UNITED STATES PATENT AND TRADEMARK OFFICE

APPLICATION NO.	FILING DATE	FIRST NAMED INVENTOR	ATTORNEY DOCKET NO.	CONFIRMATION NO.
10/777,599	02/11/2004	Ching-Wu Tseng	JCLA12098	4941

Office Action Summary

DETAILED ACTION

FIG. 2

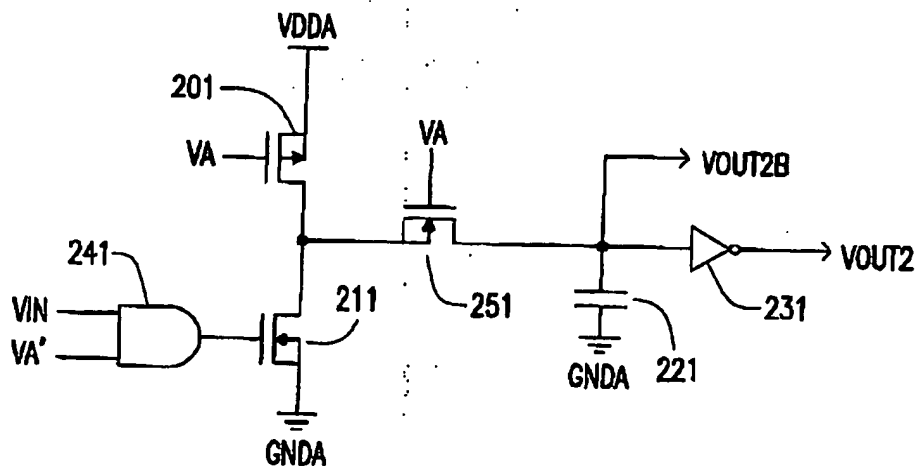
The prior art reference cited on the accompanying PTO-892 was found during the recent update search. It is cited for interest and documentation purposes only. Tseng et al.'s Fig. 3A circuit closely corresponds to the applicants' own Fig. 2 circuit. However, switch SW1 receives control signal V3, and when referring to Fig. 3B, it is noted that signal V3 is not the same as either control signal V2 (applied to the gate of transistor P1) or control signal V1 (applied to one input of the AND gate). Therefore, this reference's Fig. 3A is structurally similar to the applicants' own invention, but it does not meet the recited limitations related to the first and second control signals as recited (or understood) within the present application's claim 4.
